**MODIFICATION REQUEST:
CASUARINA TOWN CENTRE
TWEED COAST ROAD, CASUARINA
06_0258 MOD 3**

Director-General's
Environmental Assessment Report
Section 75W of the
Environmental Planning and Assessment Act 1979

February 2012

Figure 3: Proposed Retail Centre Overlayed with Building Extent as Approved (source: proponent)

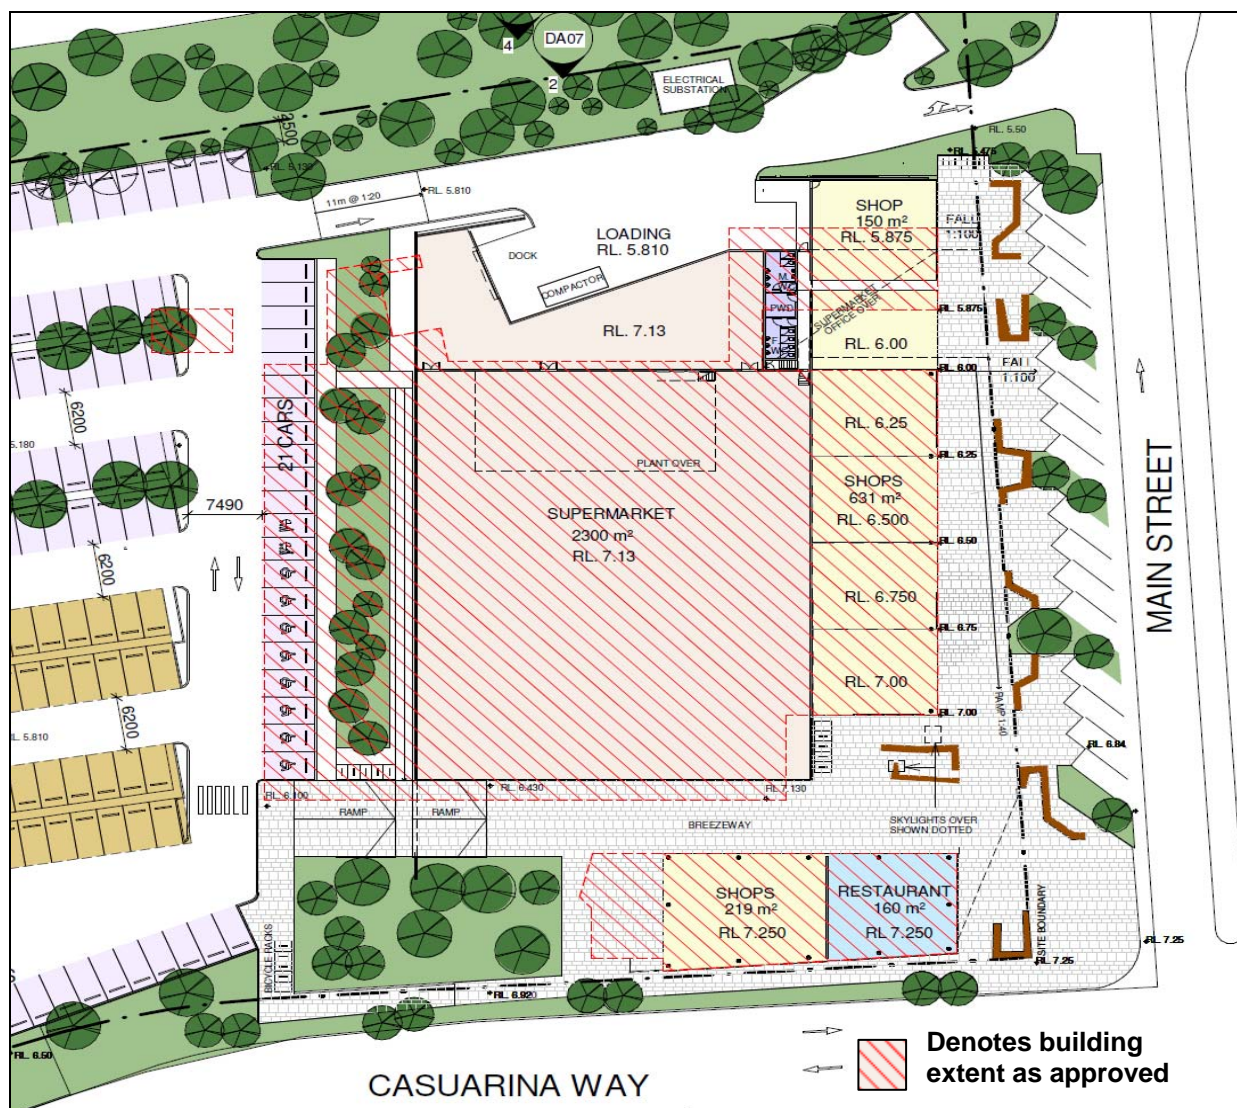
During the original assessment of the proposal, council considered the size of the supermarket at 2,500m² was too large for the population catchment. In response to the proposed modification involving a 200m² reduction of the supermarket GFA, and 150m² increase in specialty retail GFA, council did not raise any issues.

The department considers that the proposed reduction of retail centre GFA and marginal increase in specialty retail does not detract from the original approval and is supportive of this aspect of the proposed modification.

Figure 7: Modified Retail Centre – View from Tweed Coast Road (source: proponent)

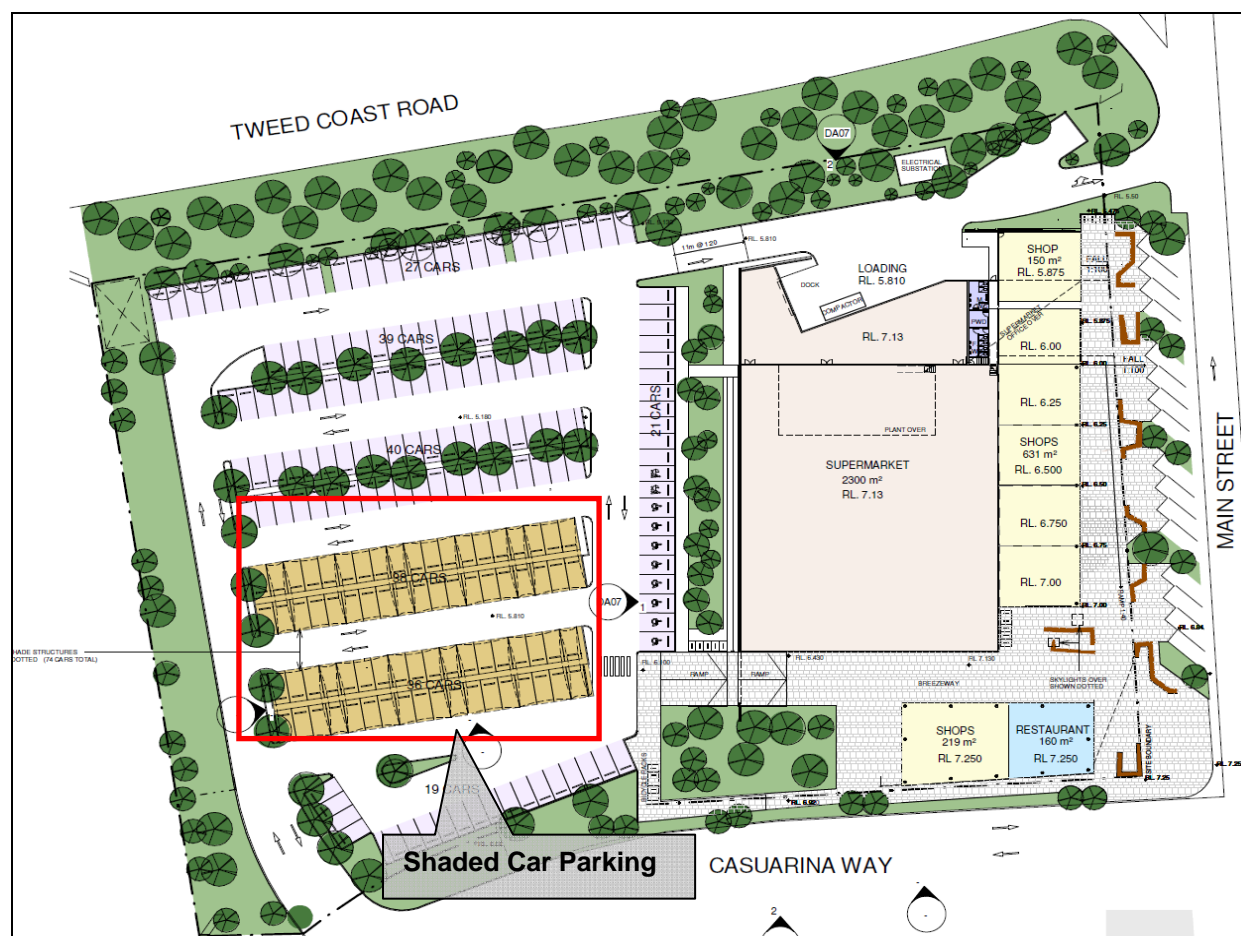
The proponent did not provide any detailed design drawings of the proposed shade structures with the modification request. It was therefore proposed to introduce a new condition as part of the Stage 1 project approval requiring the design details of the shade structures be approved by the department prior to the issue of a Construction Certificate for the retail centre.

Council advised in its submissions that the shade structures are not supported due to visual impacts from Tweed Coast Road.

The department acknowledges that the proposed shade structures will be visible from Tweed Coast Road. However, the structures will not adversely impact on the visual amenity of the area given they are to be set back from Tweed Coast Road, closer to Casuarina Way, and will be sufficiently screened by vegetation plantings. Furthermore, the positioning of shade structures over exposed car parking areas are a common feature associated with supermarket/shopping centre precincts, and it is therefore considered that the proposed structures are not out of character with the surrounding land use being for a supermarket and retail shopping precinct. It is noted that a detailed Landscape Plan is required to be prepared in accordance with Condition B32 of the Stage 1 project approval, to be approved by council prior to the issue of a Construction Certificate for the retail centre. A requirement of the Landscape Plan is to provide planting details and photomontages illustrating proposed landscaping at maturity overlain over building elevations from street frontages and adjoining the development. Council will have an opportunity to request additional landscaping along the western boundary of the site should the proposed shade structures not be sufficiently screened from view from Tweed Coast Road to council's satisfaction. The department has also introduced a new condition of approval requiring the detailed design of the shade structures to be approved by the department prior to the issue of a Construction Certificate for the retail centre.

Figure 9: Proposed Shade Structures – View Southeast from Tweed Coast Road (source: proponent)

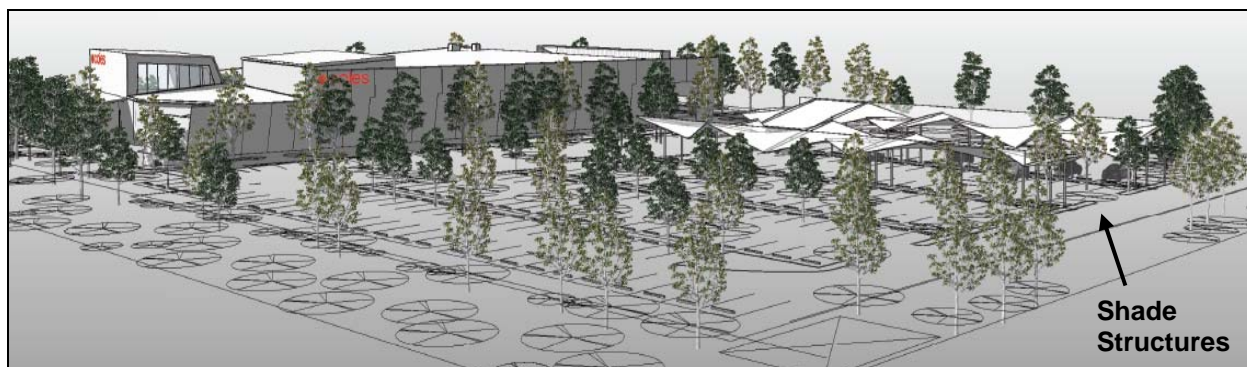
The proponent's architects, Donovan Hill, who were engaged to design the proposed shade structures describe the materials to be used as *semi-translucent tensile fabric on a cantilevered steel structure*. A *turndown of the fabric on the undulating, leading edge mimics the irregular profile of the main building fascia along Main Street*. The structure as proposed is designed with a *3m – 5.5m clearance below the undulating shade fabric*.

The proponent has advised that in response to visual impacts, the shade structures are considered acceptable given:

- only a small portion of the car park is covered;
- the structures are positioned away from Tweed Coast Road;
- the design of the canopy seeks to mimic the building design;
- the structures have a 'lightweight' appearance with limited upright supports and no horizontal walls, enhancing views through the site, and
- the structures will be viewed through, and against a backdrop of, trees and other vegetation.

Figure 11: Western Building Facade – View from Tweed Coast Road (excludes landscaping) (source: proponent)

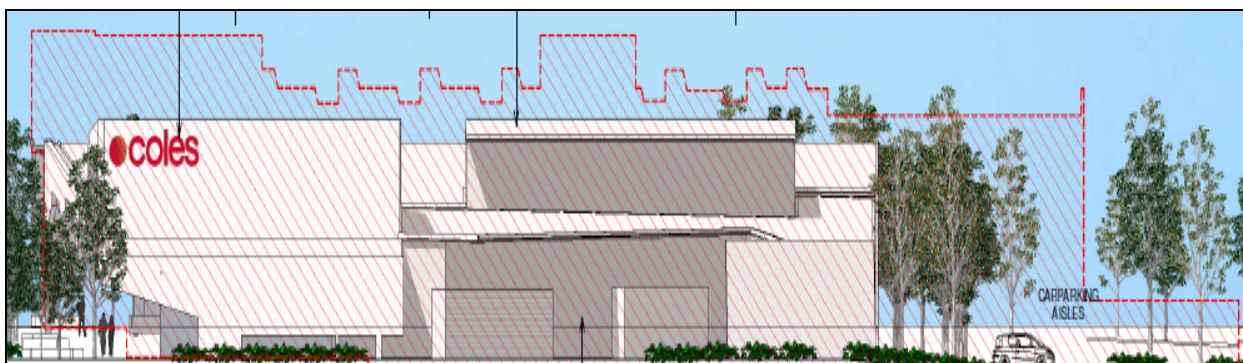
The proponent seeks to provide an additional illuminated sign to the western facade of the retail centre building. The proposed sign is 1.08m in height and 4.65m in width, and will be visible from Tweed Coast Road on the southbound approach to the site. **Figure 11** below is a photomontage of the supermarket building as proposed to be modified with the additional sign on the western building facade. The red hatched area denotes comparative building extents of the approved supermarket building in comparison to the building as proposed to be modified.

Council advised in its submission that the additional sign on the western building facade proposed as part of the modification is not supported as it detracts from the scenic amenity and character of Tweed Coast Road.

The department has considered the provisions of SEPP 64 and does not consider the proposed signage will significantly detract from the scenic amenity of Tweed Coast Road, and will in fact provide building identification from the southbound approach of Tweed Coast Road. The proponent has complied with the department's advice on the original application that signage could be better integrated on to the raised section of roof facing Tweed Coast Road and the main entry road. Furthermore, the proposed signage does not obscure or compromise important views, and is compatible with the scale and proportion of the supermarket building. **Figure 12** below shows the location of existing signage approved for the site, and the proposed location of a new illuminated sign on the western side of the building.
